Mary Ave Villas Project

Supplemental Report

CITY COUNCIL STAFF REPORT SUPPLEMENTAL

Agenda Item #8

Figure 8
Sight Distance

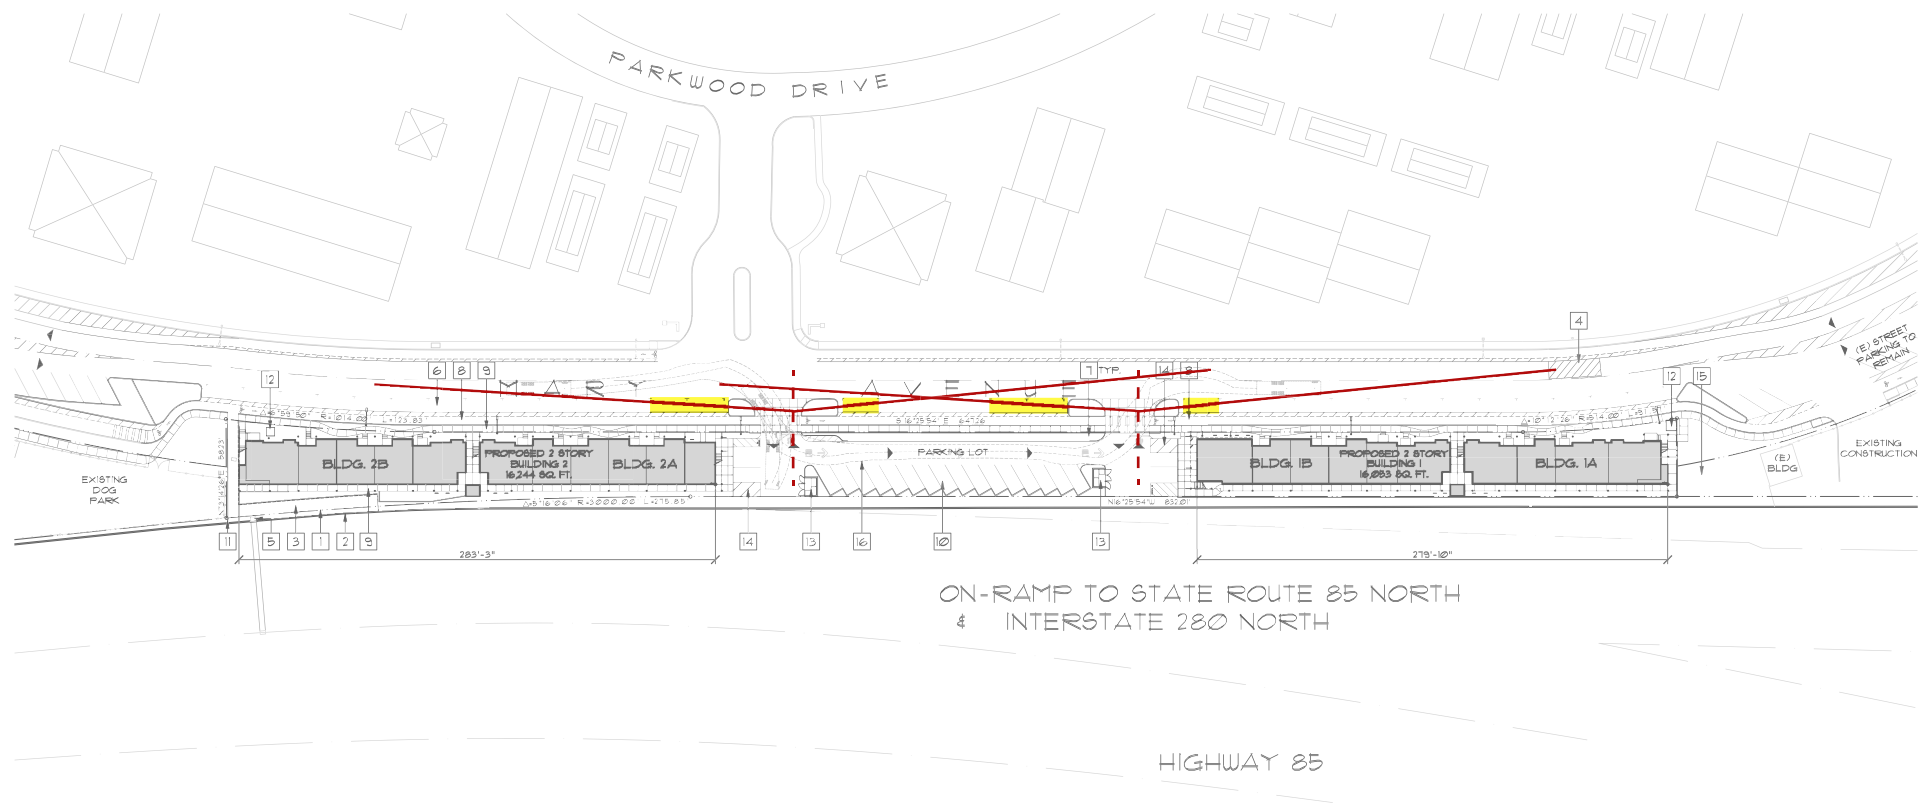
The minimum acceptable sight distance is considered the Caltrans stopping sight distance. Sight distance requirements vary depending on roadway speeds. Mary Avenue has a speed limit of 30 mph, so the Caltrans stopping sight distance is 250 feet (based on a design speed of 35 mph). Accordingly, a driver must be able to see 250 feet along Mary Avenue to stop and avoid a collision. Based on the site plan and narrow travel lanes on Mary Avenue, on-street parking next to the project driveways would potentially block the line of sight of exiting drivers (see Figure 8).

Recommendation: To ensure drivers exiting the project driveways have adequate lines of sight, it is recommended that two parallel parking spaces on the north side of each driveway and one parking space on the south side of the project driveways be removed. If the driveways are changed to one-way as recommended below, only the parking spaces next to the outbound driveway (south driveway) need to be removed. The on-street parking supply would still be adequate with the reduction of these six parallel parking spaces.
